*Amendments to the Drawings*

Attachment: Replacement Sheet  
New Sheet

FIG. 1

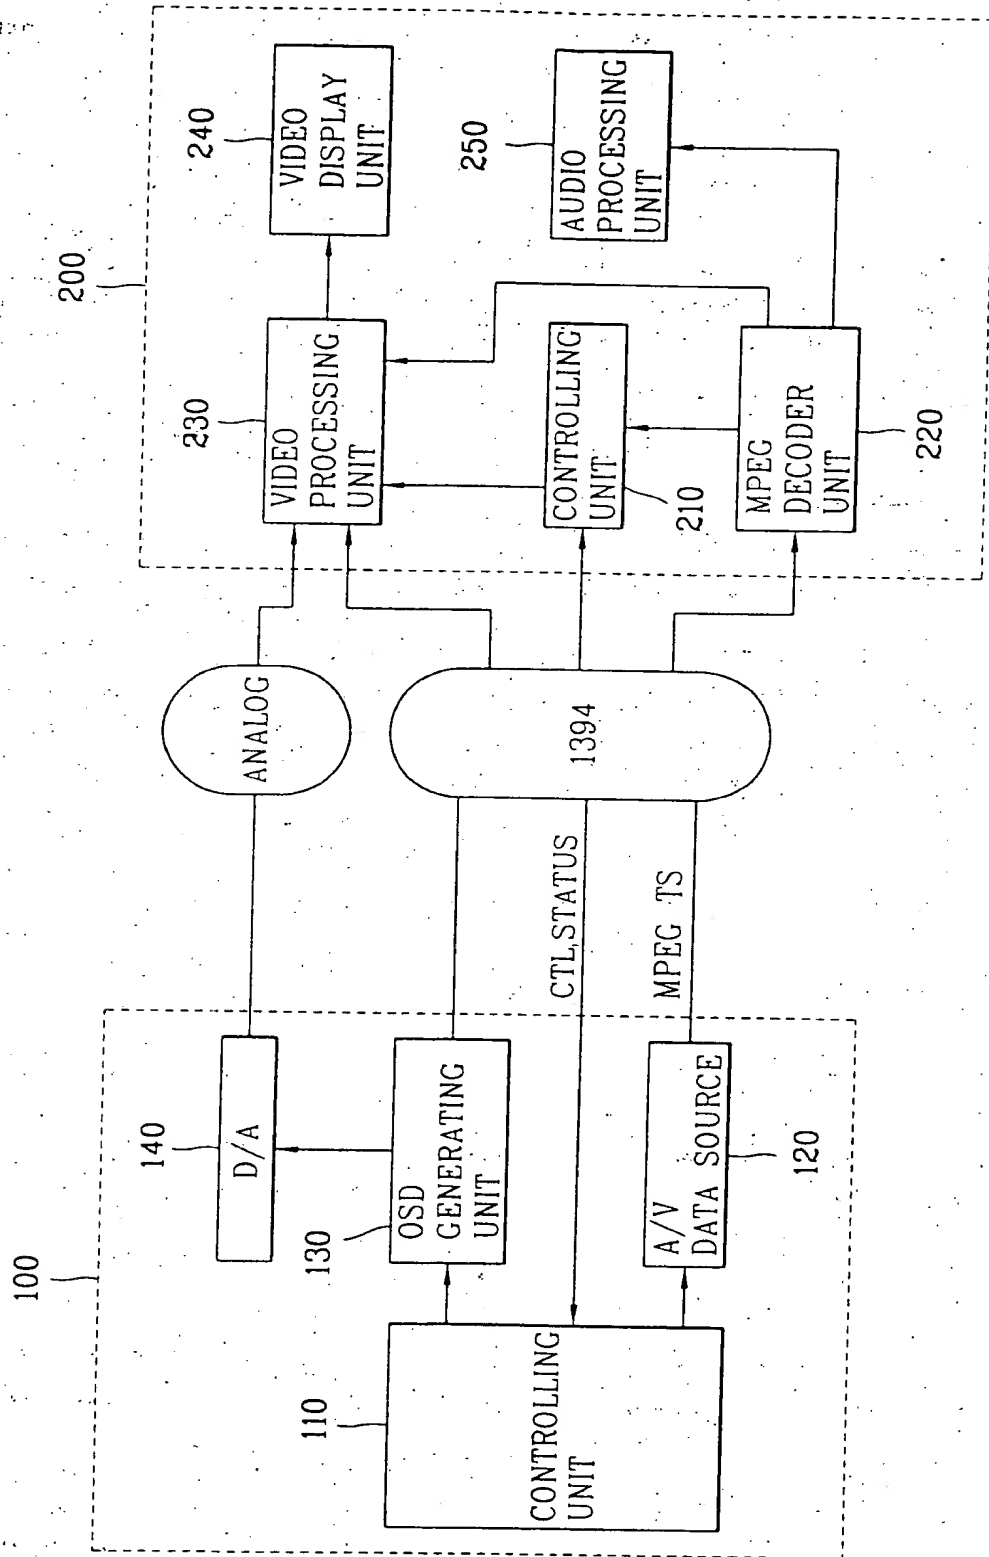
The label "Conventional Art" has been deleted from Figure 1.

FIG.3

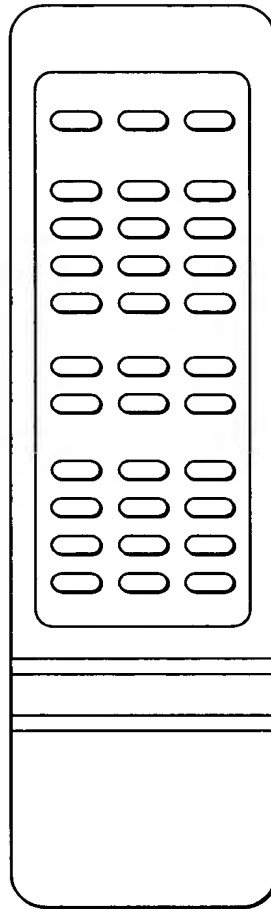
Figure 3 has been added to show a remote control.
